Subject: Transmittal of Revision 1 To Service Bulletin Number

V25000-ENG-72-0298.

ENGINE - CONVERSION - PROVIDE INSTRUCTIONS TO CHANGE THE V2500-D5 ENGINE RATING BY MODIFYING THE DATA ENTRY PLUG

V2525-D5 V2528-D5

Data Entry Plug Assembly Figure 2

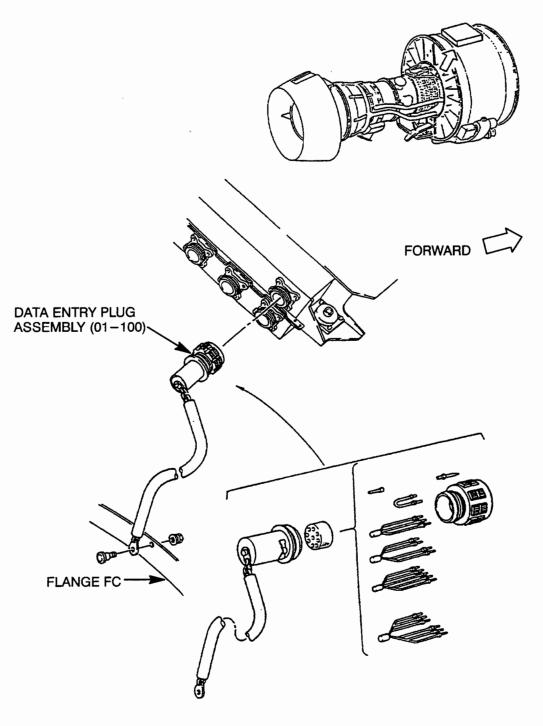
- A. Remove the Data Entry Plug by the procedure given in Reference (2), Chapter/Section 73-21-35, Repairs, VRS3500.
- B. Disassemble the Data Entry Plug Assembly, PN 2A3106, Reference (1), Chapter/Section 73-22-35, Figure/Item No. 01-100) by the procedure specified in Reference (2), Chapter/Section 73-21-35, Repairs, VRS3500 and Figure 2.

- D. Modify the Data Entry Plug Connector by the procedure specified in Reference (2), Chapter/Section 73-21-35, Repairs, VRS3500.
- E. Assemble the Data Entry Plug Assembly by the procedure specified in Reference (2), Chapter/Section 73-21-35, Repairs, VRS3500 and Figure 2.

Identification Of The Data Entry Plug Assembly To the New Part Number Figure 3

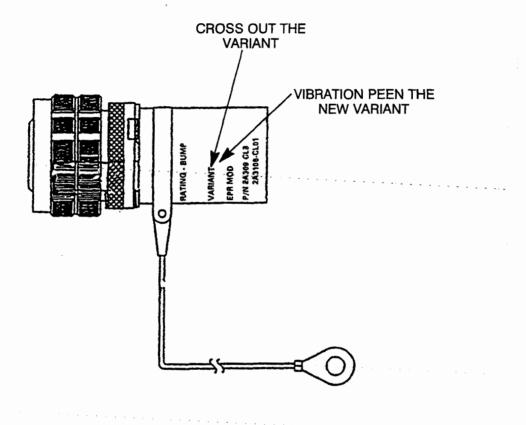
- G. Mark the Data Entry Plug Backshell with the new Variant No. by the procedure given in Reference (3), Chapter/Section 70-09-00, Marking of Parts Parts and Figure 3. Use the vibration peen method.

Location of the Engine Identification Plate Figure 4

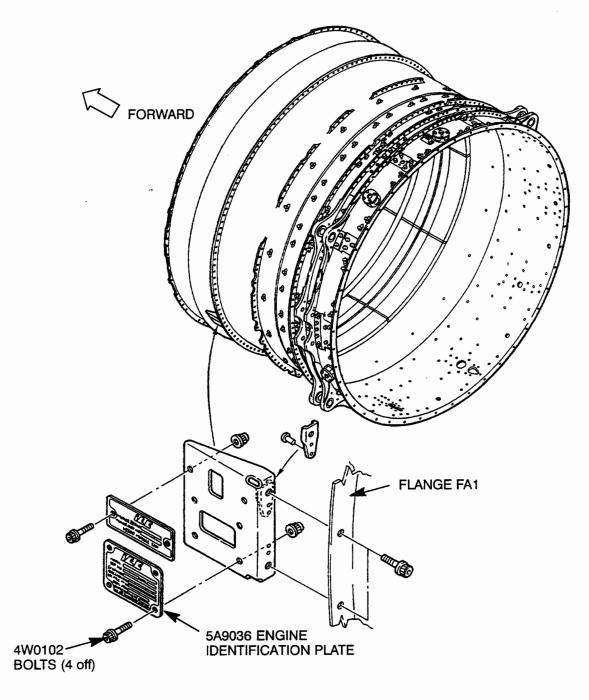
- Install the Data Entry Plug by the procedure given in Reference (2), Chapter/Section 73-21-35, Repairs, VRS3500.
- Install a new Engine Identification Plate, PN 5A9036, Reference (1), Chapter/Section 72-32-85, Figure Item No. 03-120, and Figure 4 as follows:

- Remove the four bolts (4W0102), that hold the Engine Identification Plate to the bracket.

- Give the old Engine Identification Plate to your IAE Representative.
- Get the new Engine Identification Plate from your IAE Representative.
- Install the new Engine Identification Plate with the 4W0102 bolts (4 off).

- Torque the bolts between 32 to 36 lbfin (3,61 to 4,07 Nm).
- NOTE: If a two-sided (reversible) Engine Identification Plate is installed, that already has the required information and the new variant No. on the back-side of the plate, the plate may simply be removed, flipped over, and installed again. You MUST inform your IAE representative of this action.

Contact Hole Locations Figure 5

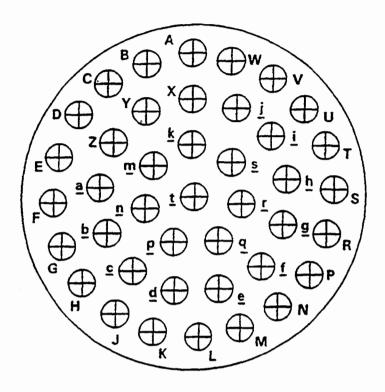
- C. Make two copies of Figure 5, Contact Hole Locations.
 - Mark the existing jumper connections from the Data Entry Plug Connector on one copy of the figure.

- Find the jumper pin connections, from Table 2, for the current engine model rating, and highlight these on the copy made in C. (1).
 - Find the jumper pin connections, from Table 2, for the variant for (3) the target engine model rating, and highlight these on the second copy of the figure.

Engine Display Panel Electronic Engine Control Adjustment/Test Figure 6

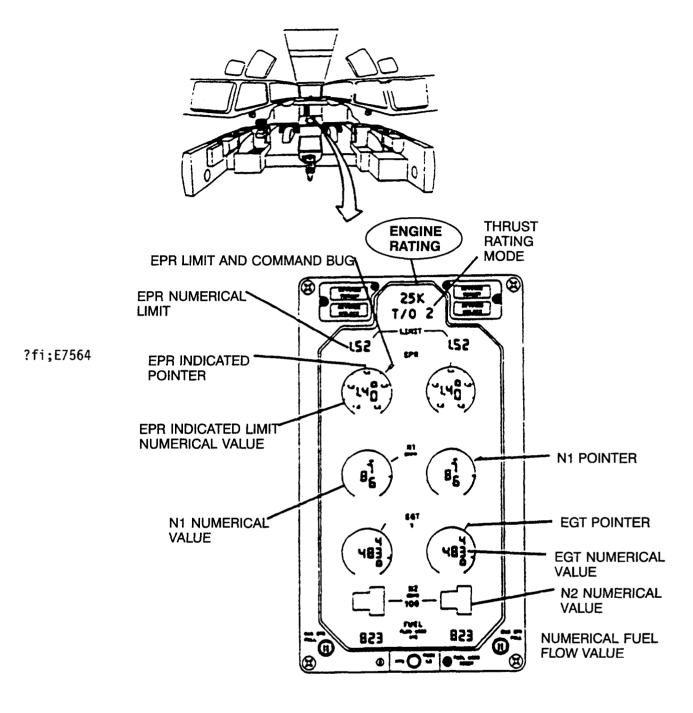
- J. Check the data entry plug wiring by viewing the Engine Rating indicated on the Engine Display Panel comparing this to the Data Plate information, when the EEC and the DEP are installed on the aircraft. Use the procedure specified in Reference (2), Chapter/Section 73-21-02 or 73-21-34, EEC Adjustment/Test. Aircraft 28V dc Power/Engine Display Panel Adjustment /Test, to view the EDP, and Figure 6.

If this does not agree, the Data Entry Plug must be corrected or replaced; until then the aircraft can not be dispatched.
